Modification Sheet No: RDSO/2018/EL/MS/0442 (Rev '1')

GR-0 indication of middle & trailing locomotives through additional signalling lamps in leading locomotive in multiple unit/consist operation of two/three locomotives.

To get GR-0 indication of middle & trailing locomotives in leading locomotive in multiple unit/consist operation of two/three locomotives.

Modified Circuit Diagram for GR-0 indication of middle & trailing locomotives in leading locomotive in Multiple Unit (MU)/Consist operation (For Non-MPCS locomotive)

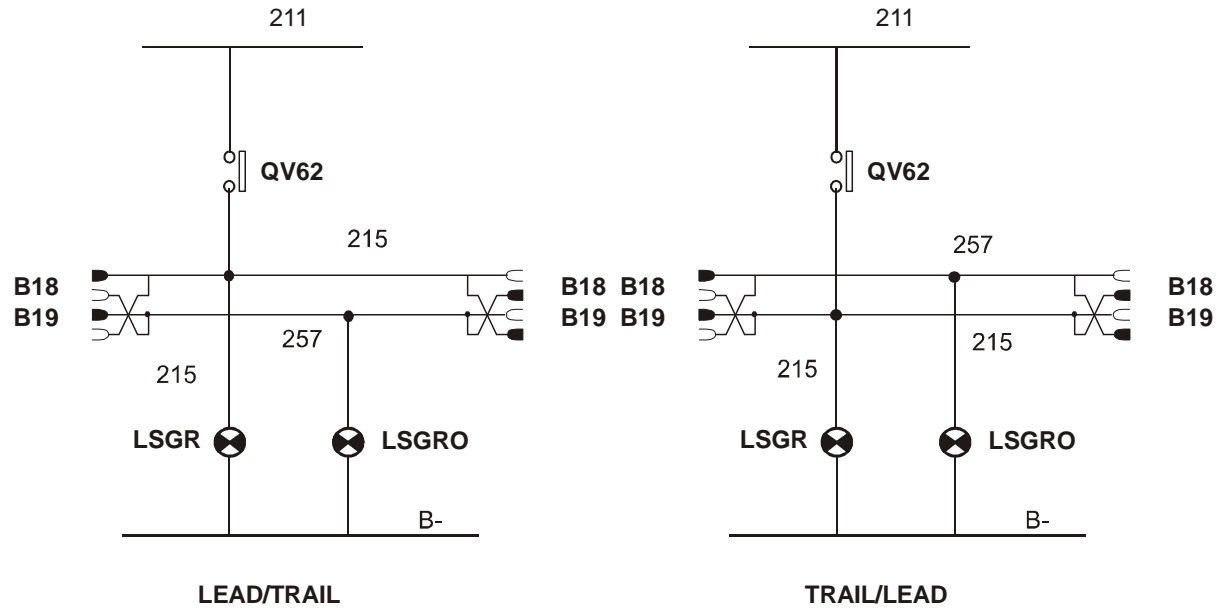
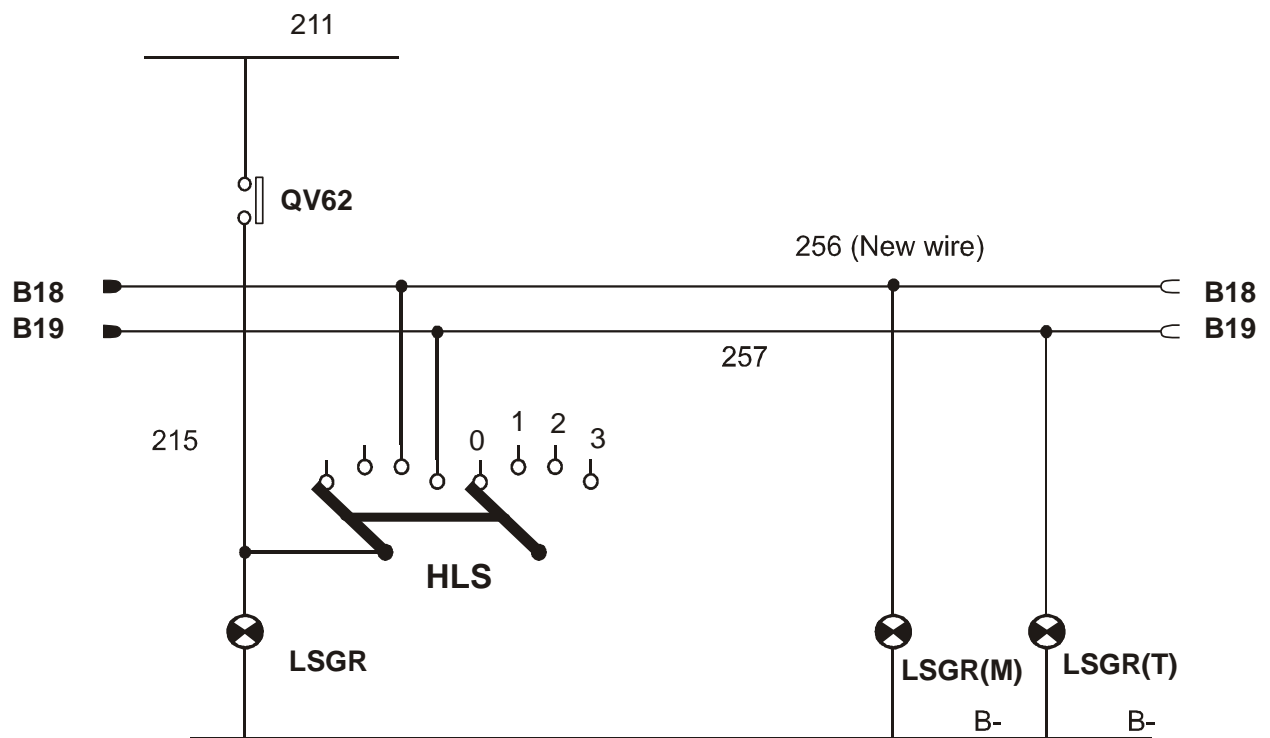
- 3.2.1 For conventional electric locomotives not equipped with Microprocessor based control & fault diagnostic system (MPCS), existing connection for giving indication of LSGR of other locomotive in leading locomotive in multiple unit operation of two locomotives is given as annexure- 'A'(as per Modification Sheet number RDSO/2015/EL/MS/0442 (Rev '0') dated 11.9.2015).
- 3.2.2 For conventional electric locomotives equipped with Microprocessor based control & fault diagnostic system (MPCS), existing connection for giving indication of LSGR of other locomotive in leading locomotive in multiple unit operation of two locomotives is given as annexure- 'C' (as per Modification Sheet number RDSO/2015/EL/MS/0442 (Rev '0') dated 11.9.2015).

- 4.3 For conventional electric locomotives not equipped with Microprocessor based control & fault diagnostic system (MPCS), modified connection for giving indication of LSGR of middle and trailing locomotives in leading locomotive in consist operation of three locomotives is given as annexure- 'B'.

- 5.1.1 Remove wire no. 215 from multiple coupler jumper pin B-18/B-19 (if connected) and connect wire no. 215 from QV62 to LSGR directly.
- 5.1.2 Remove cross connections between B-18 & B-19 (if available).
- 5.1.3 Rename the LSGRO lamp to LSGR(T) if provided, else provide additional signalling lamp LSGR(T) in both cabs at suitable location.
- 5.1.4 Provide additional signaling lamp LSGR(M) in both cabs at suitable location.
- 5.1.5 Install a four-position programmable Locomotive Selector Switch 'HLS' in switch panel for selection of leading loco, middle loco or trailing loco during MU/Consist operation.
- 5.1.6 Connect the wire 215 from QV-62 relay or LSGR lamp of locomotive to four-position programmable Locomotive Selector Switch 'HLS' as shown in Annexure-B.

- 5.1.7 Define Multiple Coupler wire B-18 as wire number 256, and connect it to position '2' of four position locomotive selector switch HLS as shown in Annexure-B.
- 5.1.8 Define Multiple Coupler wire B-19 as wire number 257, and connect it to position '3' of four position locomotive selector switch HLS as shown in Annexure-B.
- 5.1.9 Connect the wire number 257 (of multiple coupler jumper B-19) to LSGR(T) (Signalling lamp indication of GR-0 for trailing locomotive) as shown in Annexure-B.
- 5.1.10 Connect the wire number 256 (of multiple coupler jumper B-18) to LSGR(M) (Signalling lamp indication of GR-0 for middle locomotive) as shown in Annexure-B.

Modified Circuit Diagram for GR-0 indication of middle & trailing locomotives in leading locomotive in Multiple Unit (MU)/Consist operation (For MPCS locomotive)

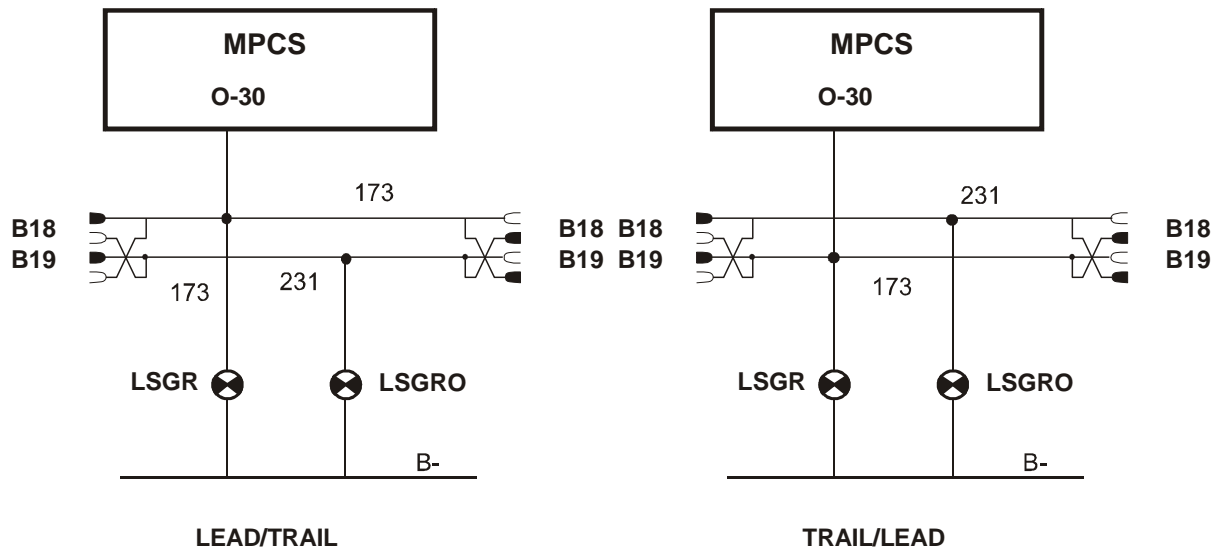
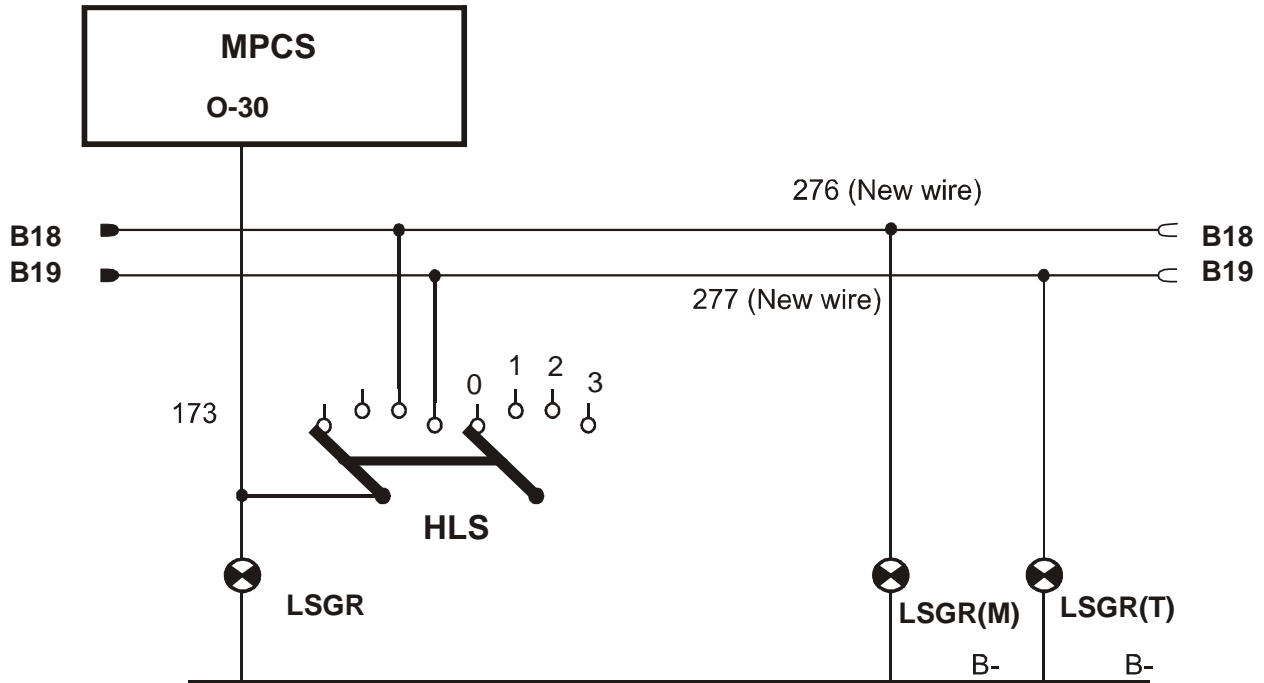
- 4.4 For conventional electric locomotives equipped with Microprocessor based control & fault diagnostic system (MPCS), modified connection for giving indication of LSGR of middle and trailing locomotives in leading locomotive in consist operation of three locomotives is given as annexure- 'D'.

- 5.2.1 Remove wire no. 173 from multiple coupler jumper pin B-18/B-19 (if connected) and connect wire no. 173 from O-30 to LSGR directly.
- 5.2.2 Remove cross connections between B-18 & B-19 (if available).

- 5.2.3 Rename the LSGRO lamp to LSGR(T) if provided, else provide additional signalling lamp LSGR(T) in both cabs at suitable location.
- 5.2.4 Provide additional signaling lamp LSGR(M) in both cabs at suitable location.

- 5.2.5 Install a four way programmable Locomotive Selector Switch HLS in switch panel for selection of leading loco, middle loco or trailing loco during MU/Consist operation.

- 5.2.6 Connect the wire 173 from O-30 or LSGR lamp of locomotive to four-position programmable Locomotive Selector Switch 'HLS' as shown in Annexure-D.

- 5.2.7 Define Multiple Coupler wire B-18 as wire number 276, and connect it to position '2' of four position locomotive selector switch HLS as shown in Annexure-B.

- 5.2.8 Define Multiple Coupler wire B-19 as wire number 277, and connect it to position '3' of four position locomotive selector switch HLS as shown in Annexure-B.

- 5.2.9 Connect the wire number 277 (of multiple coupler jumper B-19) to LSGR(T) (Signalling lamp indication of GR-0 for trailing locomotive) as shown in Annexure-B.

- 5.2.10 Connect the wire number 276 (of multiple coupler jumper B-18) to LSGR(M) (Signalling lamp indication of GR-0 for middle locomotive) as shown in Annexure-B.
